Groundwater Application Review Summary Form

Application # G- 19054

PUBLIC INTEREST REVIEW FOR GROUNDWATER APPLICATIONS

TO: Water Rights Section Date 8/8/2023
 FROM: Groundwater Section Dennis Orlowski Halley Schibel/Travis Brown
 Reviewer's Name
 SUBJECT: Application G- 19054 Supersedes review of 2/1/2022
 Date of Review(s)

Well Statistics for Sections 3S/3E-28, 29, 32, and 33 and 4S/3E-4 and 5

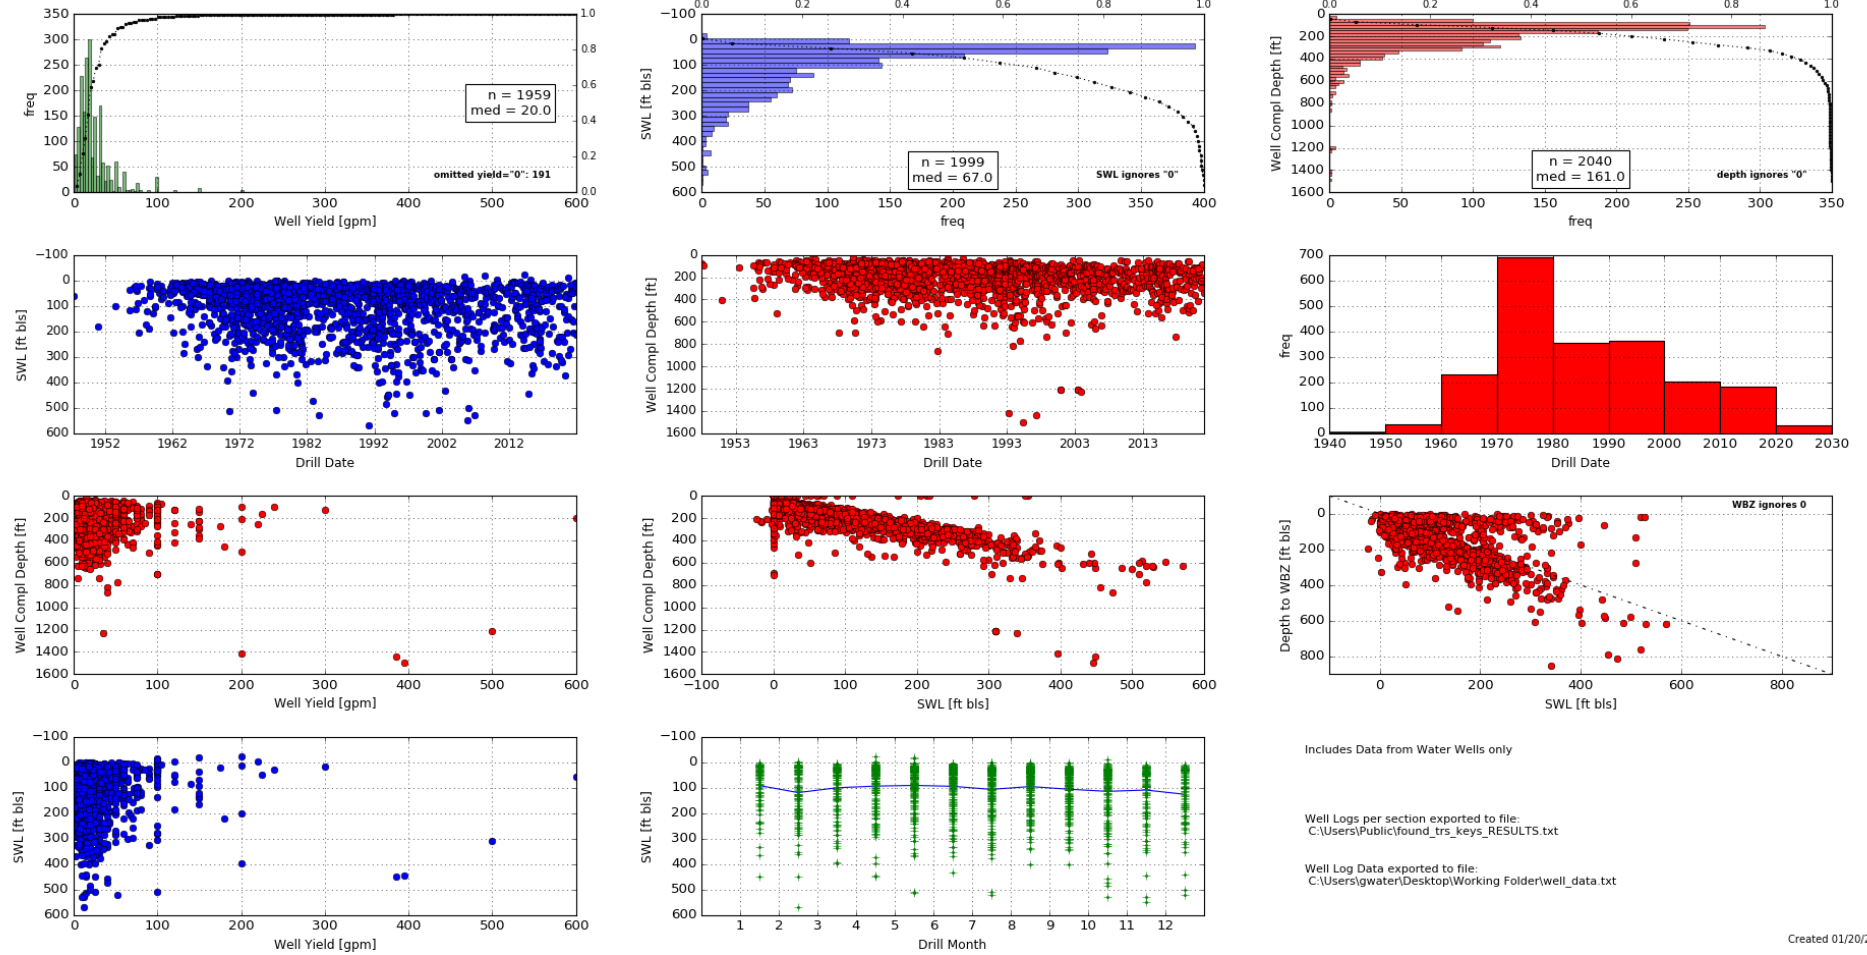
The proposed well is significantly deeper than existing nearby wells and therefore lithologic and water level data is sparse. The proposed rate (~112 gpm) is greater than most wells nearby (see attached well statistics), although data for deep CRB wells is sparse. Applicant identified CRB as the proposed aquifer, but regional geologic maps and well logs (see attached cross section) indicate that the top of the CRBs is between -200 and 0 ft above mean sea level, whereas the proposed well will reach a maximum depth of 29 ft above mean sea level. A well constructed as proposed will likely not produce from the proposed aquifer. A condition to allow groundwater production from no shallower than 980 ft below land surface is recommended to allow production only from the CRBs, but this number may change as more evidence (drill cuttings) becomes available regarding the actual depth of the CRBs.

Cross-section of nearby CRB wells

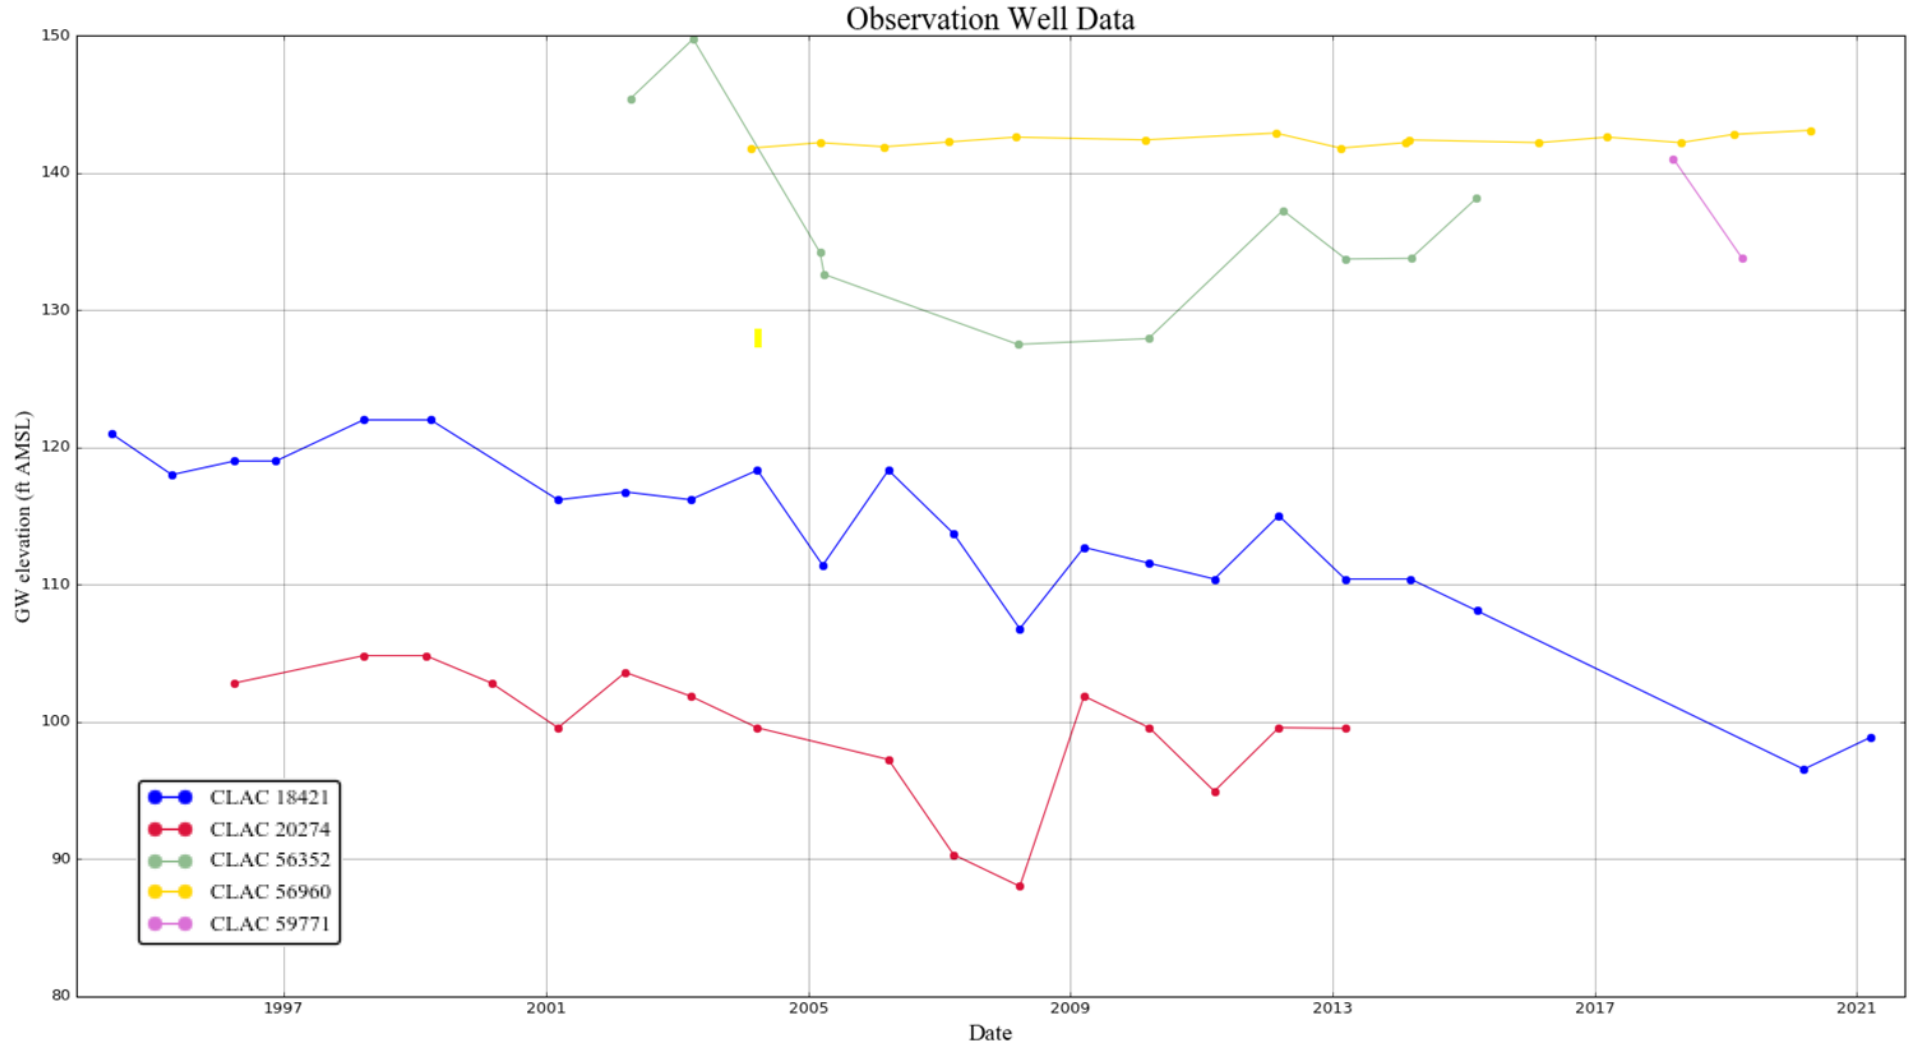
³Applicant stated approximately 350-400' based on "nearby deep CRB wells," however, nearby CRB wells (CLAC 18421, CLAC 20274, CLAC 56352, CLAC 56960, and CLAC 59771) indicate water level elevations closer to 90-150 ft above sea level, or roughly 830-890 ft below land surface at the applicant's proposed well.

Basis for aquifer confinement evaluation: Well proposed to draw from the Columbia River Basalt (CRB), locally overlain by the Troutdale Formation and Boring Lava. Water well reports for regional CRB wells (CLAC 18421, CLAC 59771, CLAC 56352, CLAC 20274, CLAC 56960) indicate water levels above the top of the relevant water-bearing zones, as do reports for shallower wells drawing from the Troutdale Formation. Based on the available evidence, the aquifer is confined.
